**CAPITOL ZONING DISTRICT COMMISSION
STAFF REPORT
8/24/2016
TDM/BIM**

Location: 1301 South Spring Street
Applicant: Dan Rhoda / Rock Capital Group, LLC for Matthew & Elizabeth Mentgen
Permit Types: Certificate of Appropriateness and Conditional Use Permit

Project Description: This application is for a Certificate of Appropriateness to allow the construction of a new, two-story apartment building and a Conditional Use permit to use the property as a multi-family residential dwelling with five units.

Fence height and setback requirements for a corner residential lot with an adjacent residence.

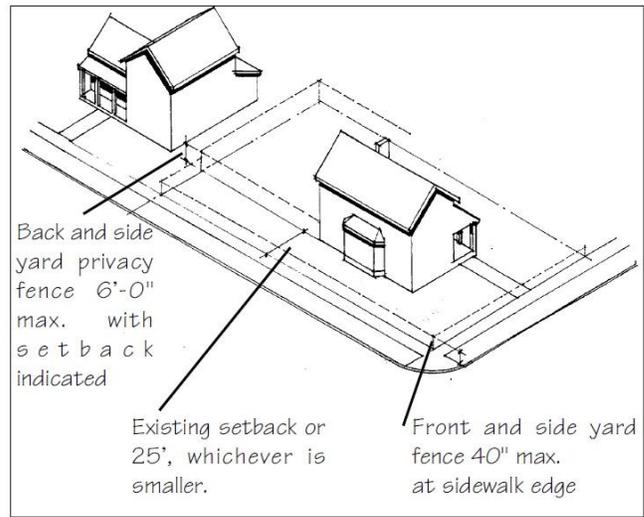
Staff finds the proposal to be mostly consistent with these standards. Because there is no adjacent residence, the fence proposed for screening the trash cans between the parking area and 13th Street is in the rear yard as shown in the Design Standards diagram on the left and therefore can be up to 6' tall. The proposal to use stained horizontal boards is not an exact copy of traditional privacy fences, but the texture and materials are in character with those seen historically. Similarly, the fence proposed for screening the HVAC units on the south side of the building is consistent with these standards.

date: 8/15/2016	project: 1301 S Spring Apartments	title: Axons	sheet number: T3.01
-----------------	-----------------------------------	--------------	---------------------

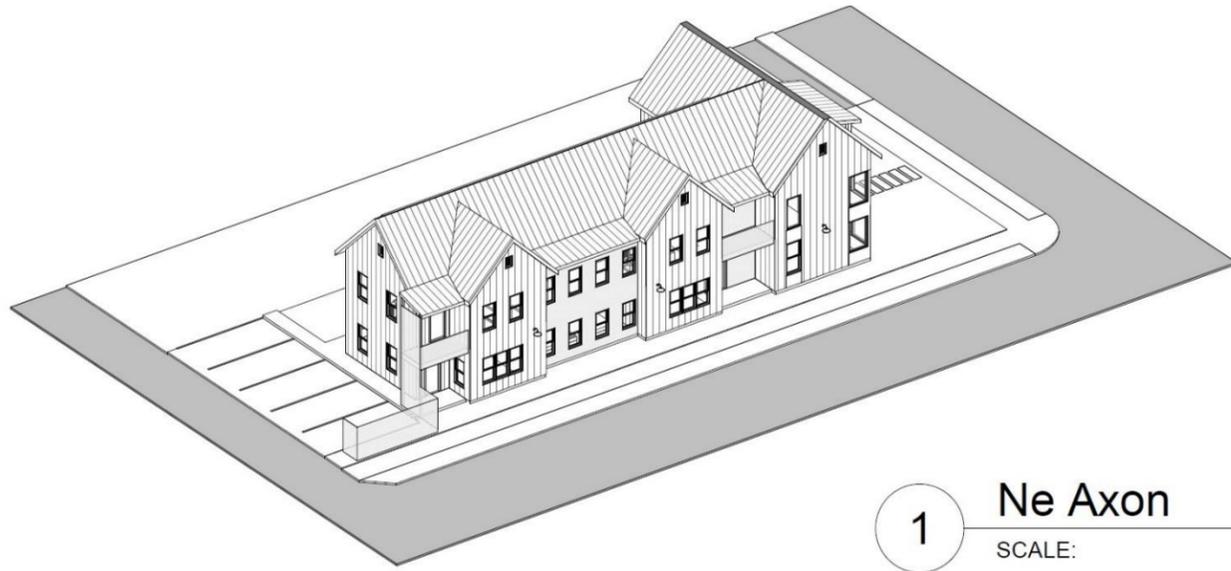
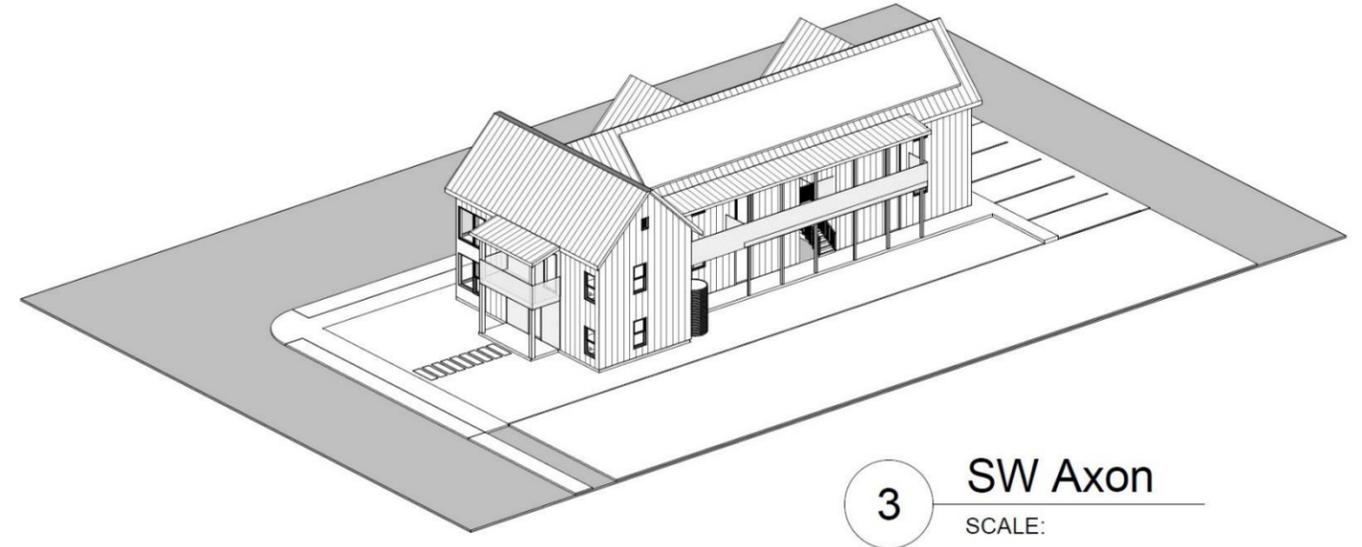
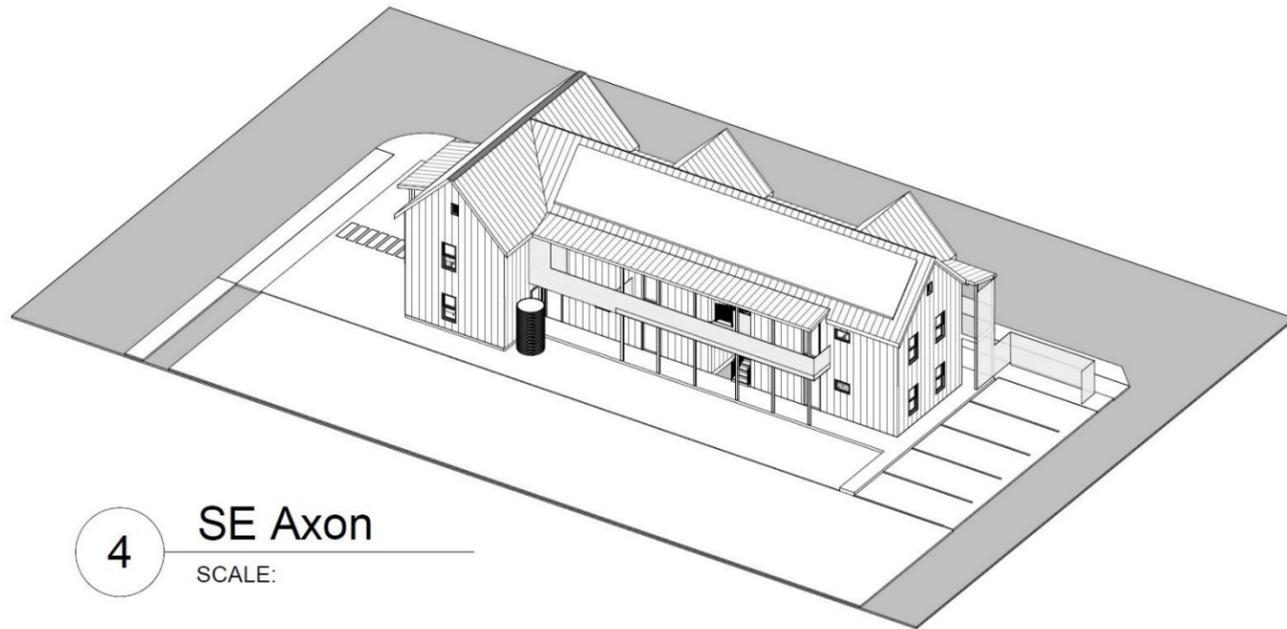
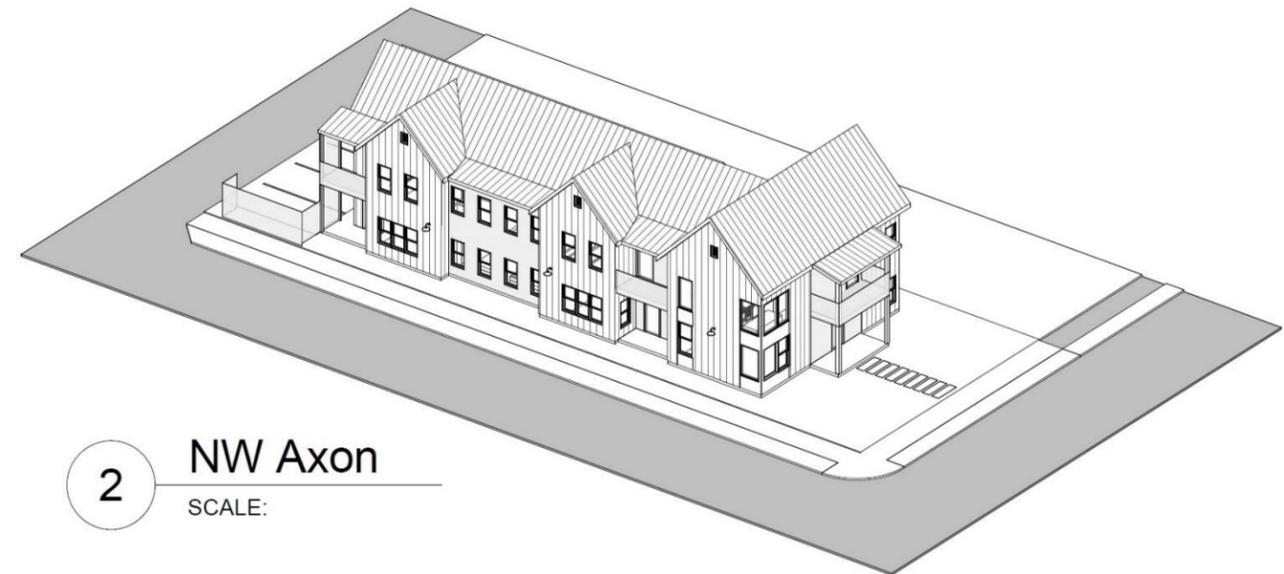
CZDC staff note: these views show an earlier version of the window and porch arrangement. The footprint, shape, and roof planes depicted are accurate, but refer to the views on pages 12-14 for details.

1301 S SPRING - Site Plan

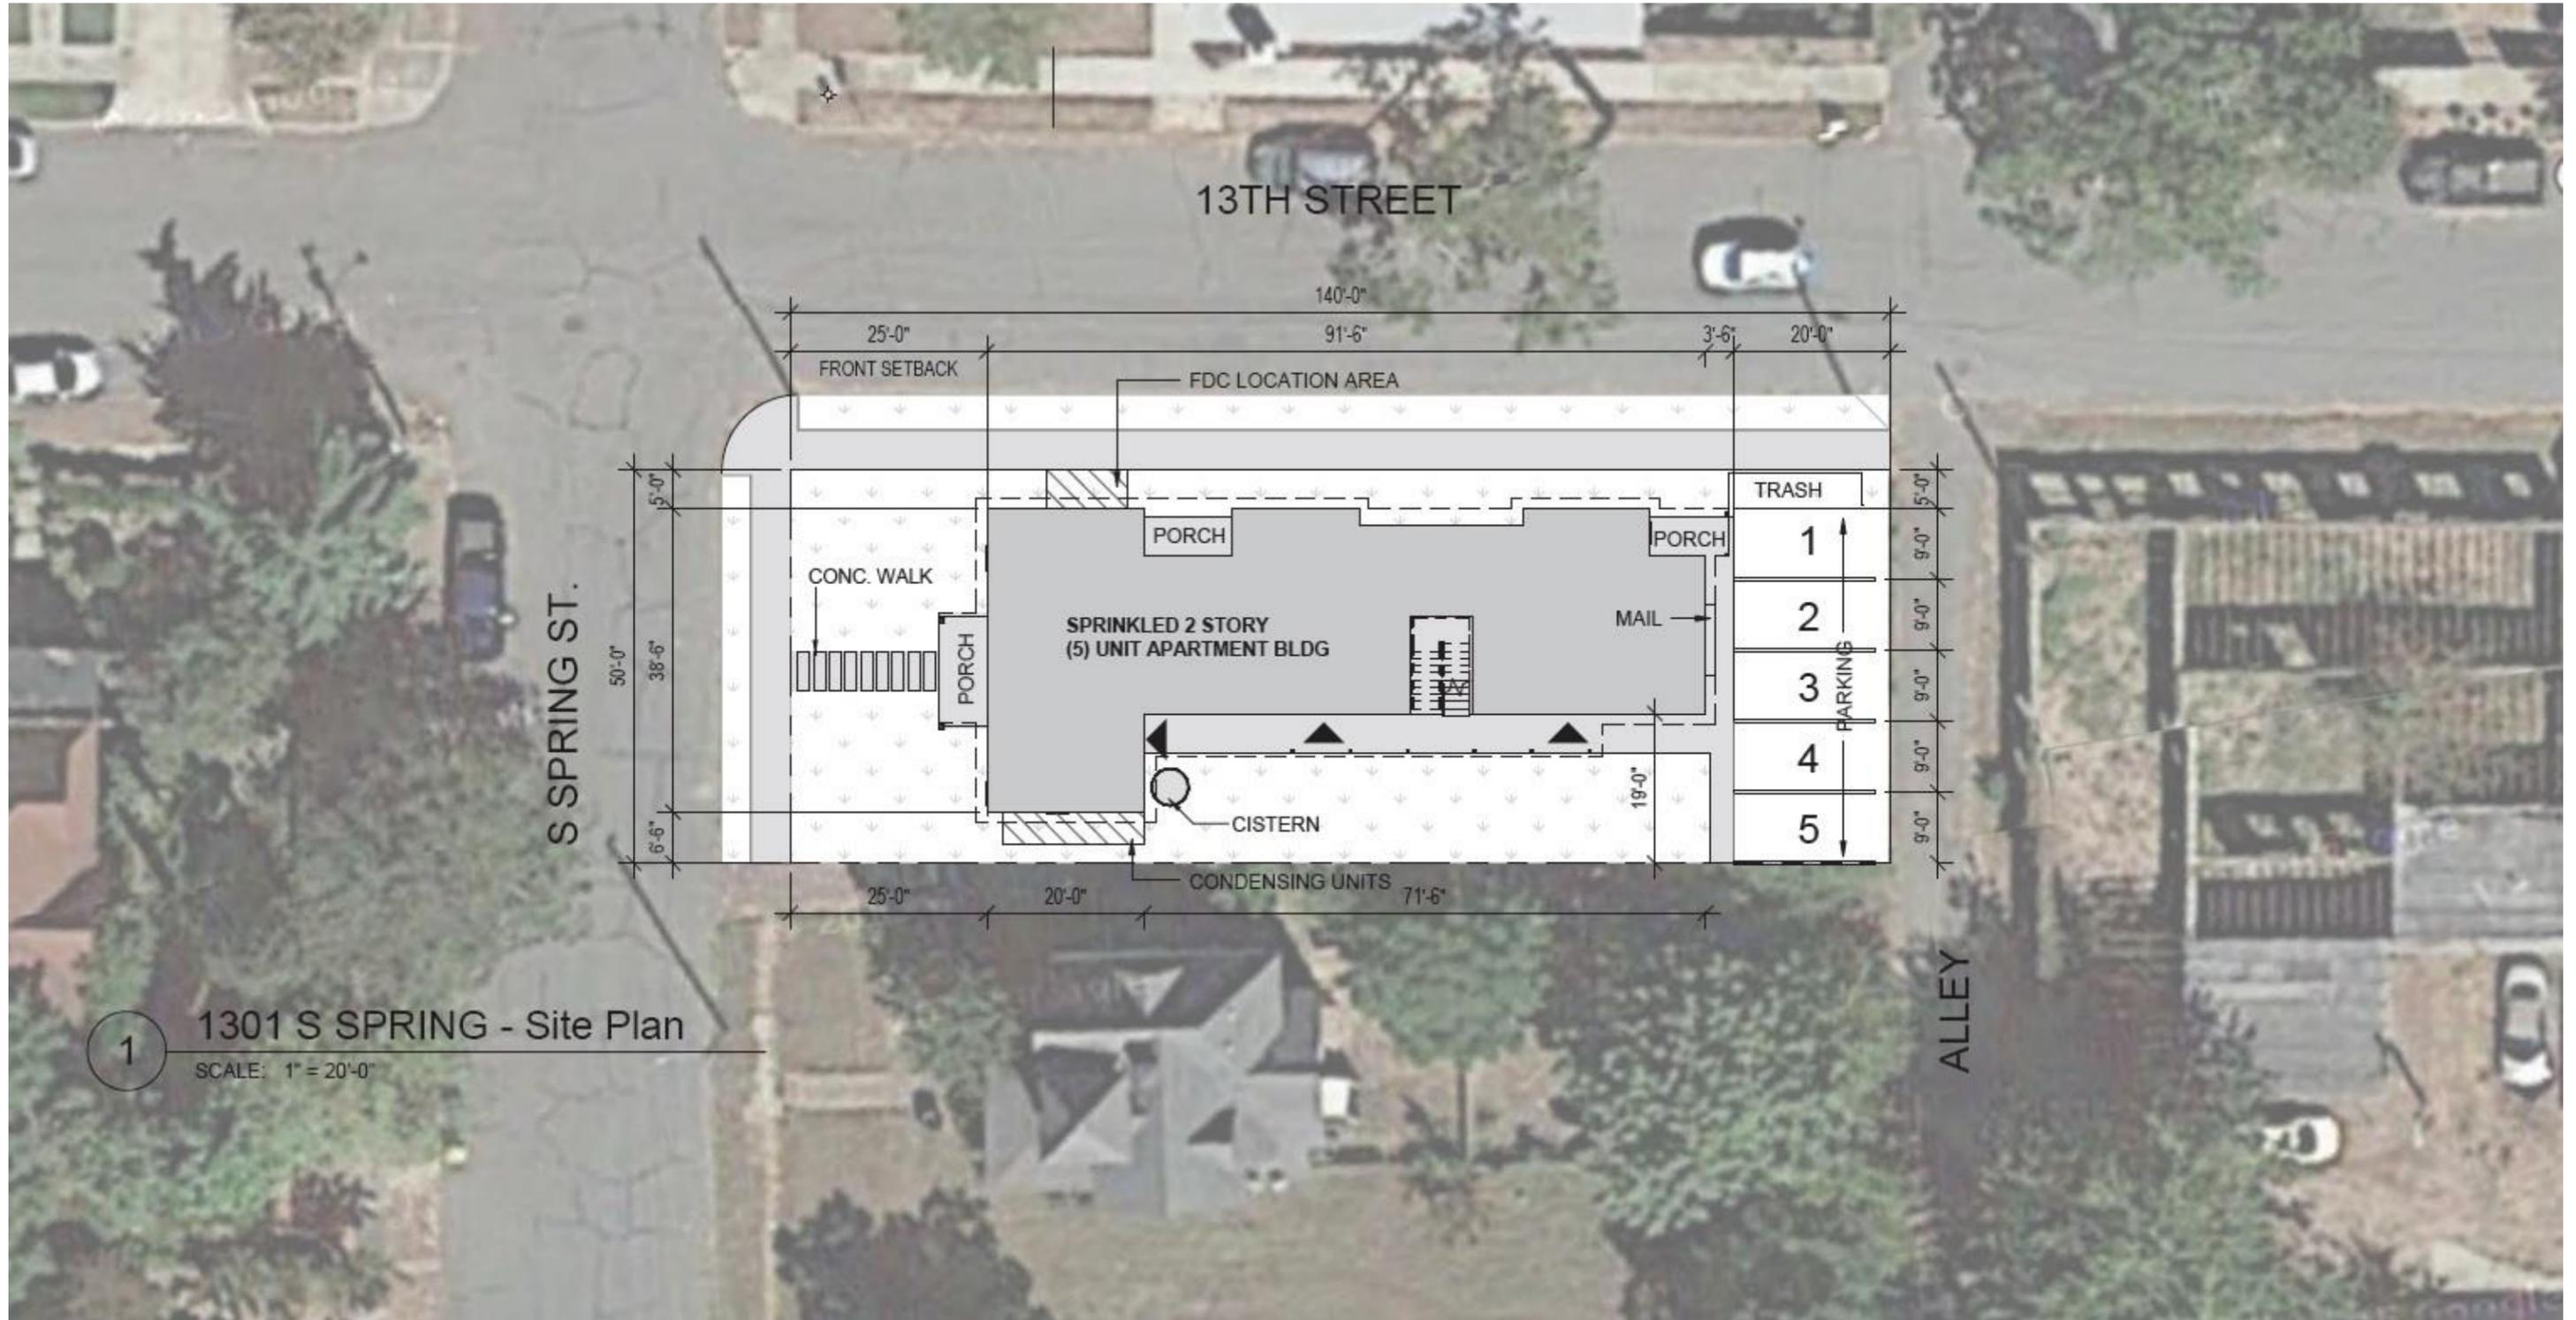
Minimum rear yard setback = 25 feet
Staff finds the proposed 25 ft setback is NOT consistent with this requirement. The site plan indicates a rear yard setback of 23'-6", or 18" short of the 25' minimum.

Setback ... The Commission, with review, may reduce a required setback by 25% in cases where a lot is smaller than what is typical for the Area, is not accessible from an alley, or is otherwise irregular due to its shape or platting.
Staff finds the 50'x140' lot to be typical for the area, is accessible from the alley, and is not irregular due to shape or platting. Therefore, staff finds the rear yard setback should not be reduced.

- 1) That all state and city codes be followed at all times;
- 2) That the property be maintained in a neat and safe condition at all times;
- 3) That a site plan showing rear setback of 25' be presented prior to staff issuing the permits; and
- 4) That a matte, non-metallic roof finish proposal be submitted prior to staff issuing the permits.
